Historic Preservation Commission

April 9, 2020

1636 2nd Avenue SE

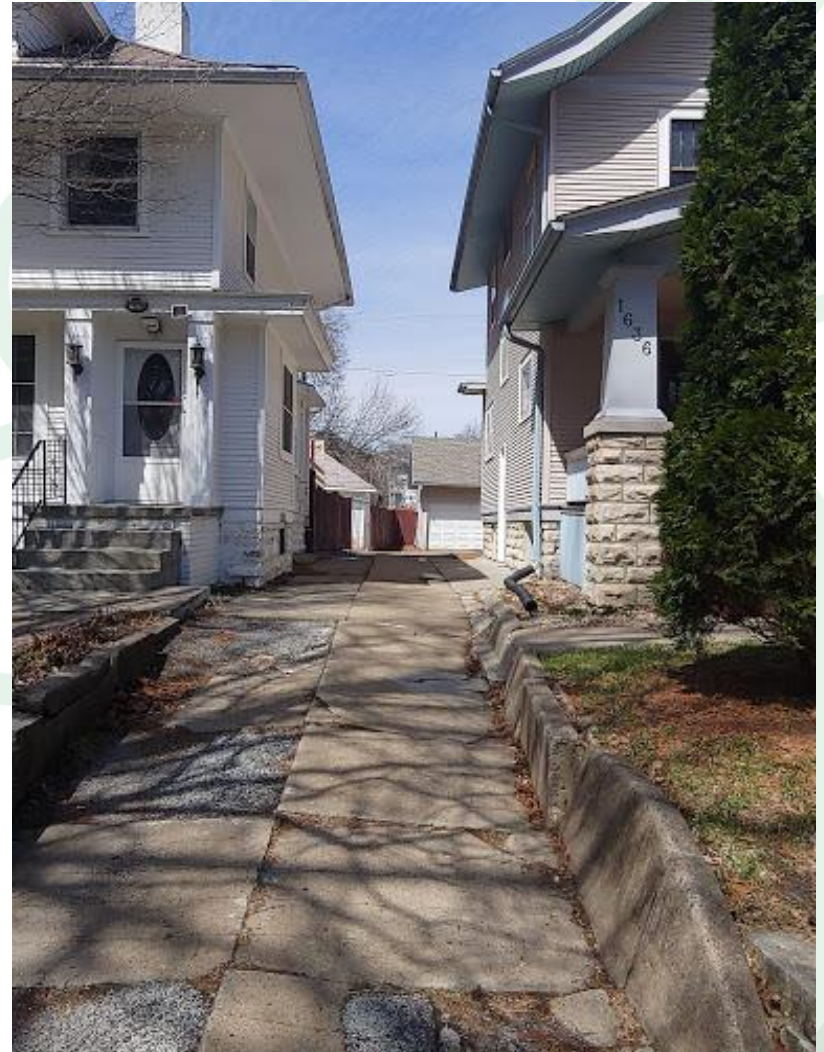
- There was a storm door on the front before, as this picture demonstrates
